**AGENDA**  
**Planning and Zoning Commission**  
**October 16, 2024 – REGULAR MEETING**  
**5:30 PM**

| <b>Agenda Item:</b>           | Conditional Use Permit for the Karns Meadow Master Plan to allow Outdoor Recreation uses within Karns Meadow Park (P24-130) | <b>Public Comment:</b> | Yes                 |

# Karns Meadow Masterplan Development Conditional Use Permit

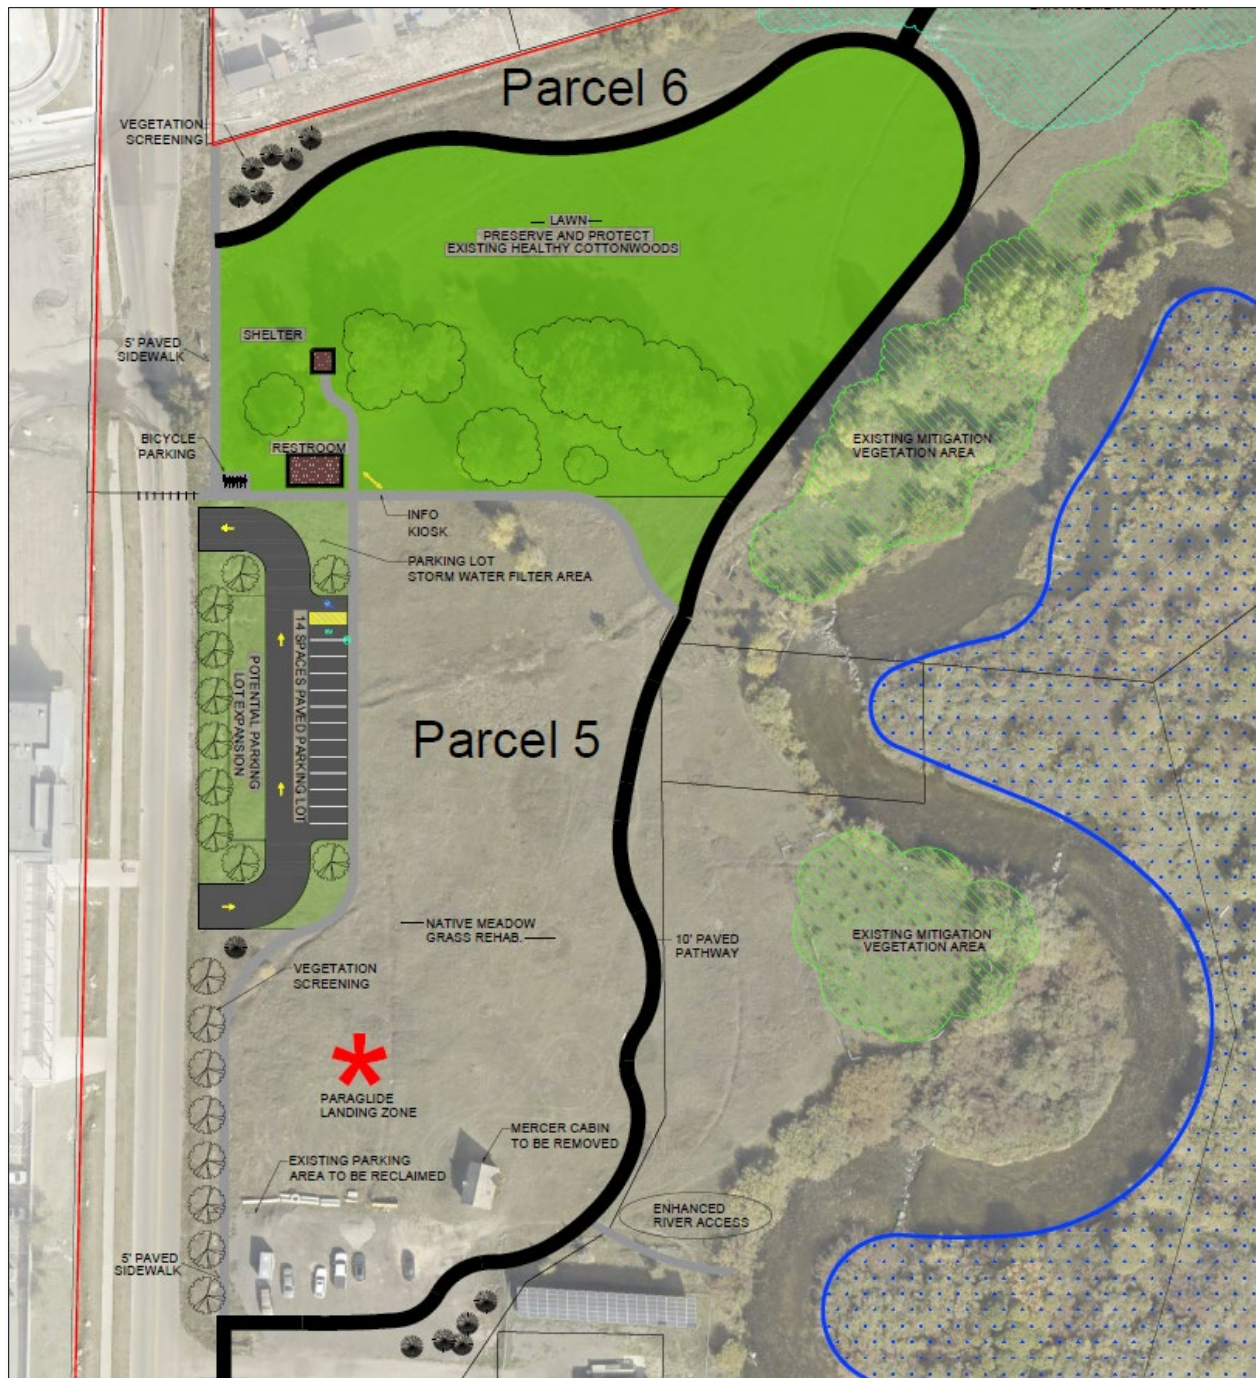
One of the project's main regulatory issues is determining the proper parking requirement. Outdoor Recreation uses require an independent calculation in both P/SP and P zones which puts the burden on the applicant to justify the parking demand specific to the needs of the use. Because there is no specific parking standard for a public park similar to parking standards used for brick-and-mortar businesses such as a restaurant or an office, the applicant considered the anticipated number of daily users of the park based on the demands of existing parks, factored in that a large percentage of users live within walking or biking distance, and considered that Karns Meadow is intended to be used primarily by walkers and bikers and will not be a gathering space for special events and private parties similar to other Town parks. The applicant states that based on these considerations, they do anticipate that the majority of users will access the park on foot or bike, some of whom may use the park as a cut-through, so the parking was intentionally set low to incentivize non-motorized travel to the site. The applicant further states that if parking demand exceeds the provided parking, an additional 14 spaces could be added, for a potential total of 28 spaces.

Based on the factors considered and presented by the applicant, staff finds that 14 spaces are sufficient to meet the park's needs. The proposed master plan is not intended to be used as intensively as other Town parks such as Miller Park or Phil Baux but is rather designed and intended to be a lower intensity "Natural Park" primarily serving walkers and bikers. Staff finds that the proposed parking strikes a good balance of providing parking and access for those who aren't in walking or biking distance, especially those with disabilities, but also doesn't incentivize single-vehicle trips by treating the parking lot as a trailhead similar to the Cache Creek parking lot. Another reason staff supports the proposed parking plan is because the picnic shelter will not be available for reservation for private parties or events which will reduce the potential for larger gatherings and further justifies setting the initial parking amount lower.

If in the future the parking demand increases to the point where the initial 14 spaces are not sufficient, staff supports the idea of setting aside the expansion area that could add up to 14 more spaces. The EA analysis assumed a disturbance area equal to 24 parking spaces so the additional 14 spaces could be added in the future without the need to amend the EA or master plan because the larger parking lot is being evaluated now (and potentially approved) as part of the current CUP process. One outstanding question is what triggers the need for additional parking, and if deemed necessary, who makes that decision (i.e., staff or Council)? Staff's initial response is that because the conservation easements and zoning allow parking on Tract 5 with no specified minimums or maximums, and because the larger parking lot was analyzed in the EA, staff recommends that TCP&R be permitted to add the future spaces without additional formal approvals per this CUP (i.e., do not need to amend the master plan) but with prior notification to Town officials. Since the future expansion area is relatively small and does not impact the higher-value habitats such as the Willows, Cottonwoods, or wetlands, this further adds to staff's justification for letting TCP&R decide.

### **Loop Pathway and Bridges**

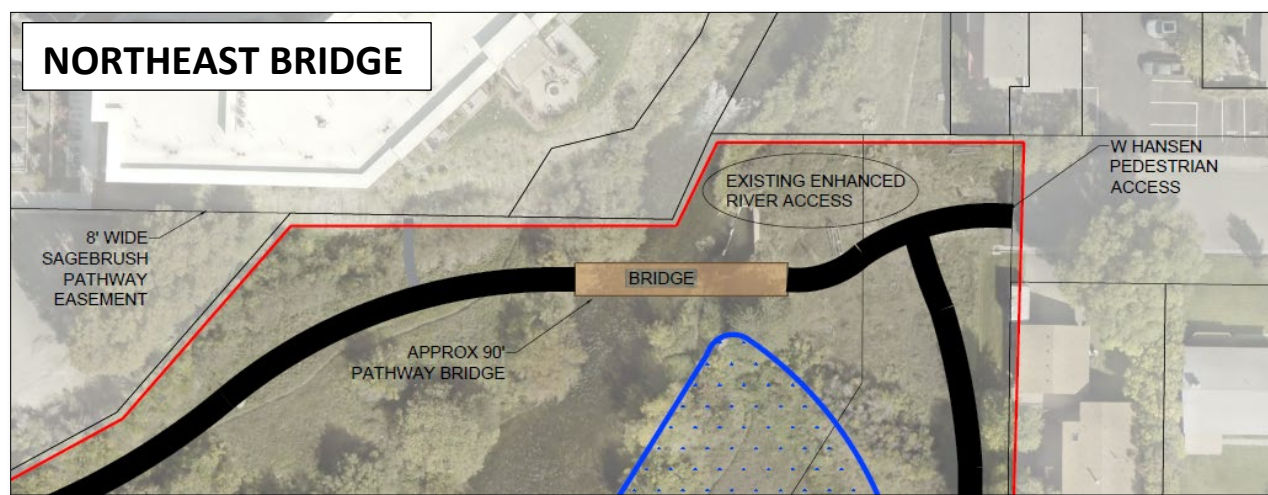
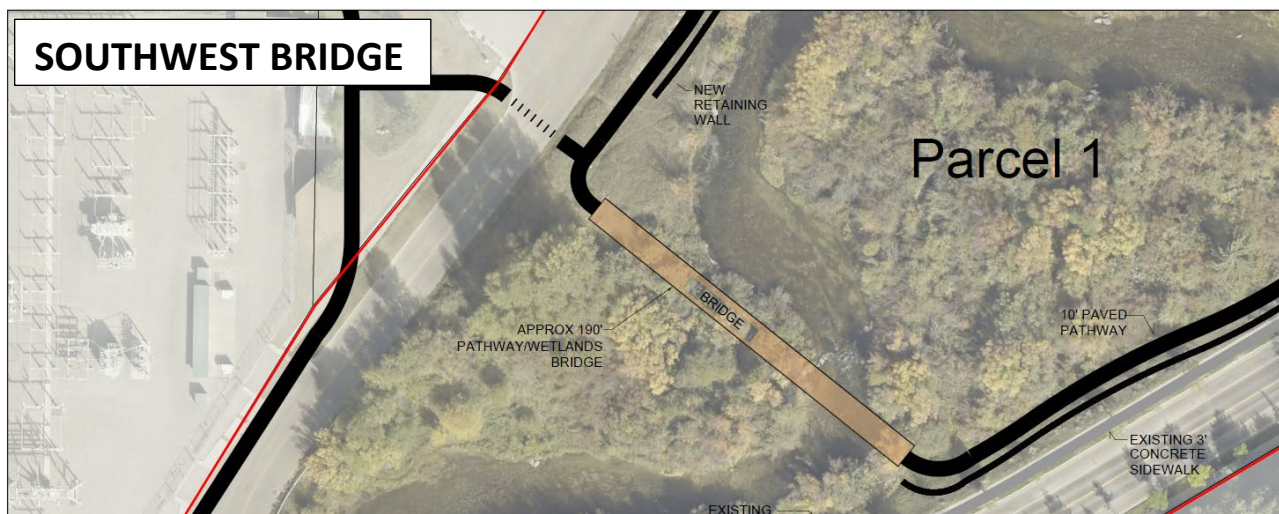
The EA, however, did provide recommendations on the pathway location based on efforts to minimize impacts on wildlife and their habitat. The pathway alignment that resulted from the EA, which is highlighted in the

proposed CUP, does seek to avoid the creek setback buffer, the wetland buffer, and higher-value habitat areas such as Willows to the greatest extent possible for a loop pathway. The majority of disturbance occurs in areas with Agricultural Meadows habitat type which are lower in wildlife habitat value. Although the pathway is mostly independent of any existing street sidewalks, there is a +/-1,000 linear foot stretch along Snow King Avenue (starting at Flat Creek Drive) where the pathway merges with the sidewalk. This particular stretch of Snow King Avenue has site challenges due to grade change and so the proposed plan calls for the removal of the existing 4' sidewalk and replacing it with the 10' multi-use pathway. Staff, including Pathways Coordinator Brian Schilling, find that merging the sidewalk and pathway along this section of Snow King Avenue is a logical solution to the grade change and finds that it reduces redundancy and impacts on the park. The final pathway alignment, however, will be field-fitted to ensure its impact does not exceed what was contemplated in the EA, and if possible, be aligned to avoid habitat impacts beyond the EA.

Staff did observe that the proposed site plan does not appear to accurately reflect the dimensions of the NL-3 zoned portion of the park on Tract 4 that was approved as part of the most recent Zoning Map Amendment. Essentially, the actual NL-3 portion is wider than what is drawn and could potentially overlap with the proposed pathway. This portion of Tract 4 has future development rights for single-family home development (i.e., three future NL-3 lots) and to fully understand the extent to which the pathway overlaps these future lots, assuming it does overlap, staff has added a condition of approval requiring the applicant to update the site plan with accurate dimensions prior to Town Council review. Ultimately staff would prefer that the final pathway alignment avoid overlapping with the NL-3 zoned portion to remove any potential for conflicts with future development. However, if they overlap it would not automatically mean that development potential is impacted. At this time, staff is not posing any initial concerns as it relates to the master plan or pathway alignment but is requiring an accurate site plan so that the Town Council, who owns Track 4, is aware of any potential encumbrances on their residential zoned land. Staff has flagged this as a key policy question for the Town Council.

2. Prior to Town Council review, the applicant shall revise the site plan to accurately depict the dimensions of the NL-3 zoned portion of Tract 4.
3. Prior to Town Council review, the applicant shall demonstrate the final amount and location(s) of bike parking in accordance with the LDRs.
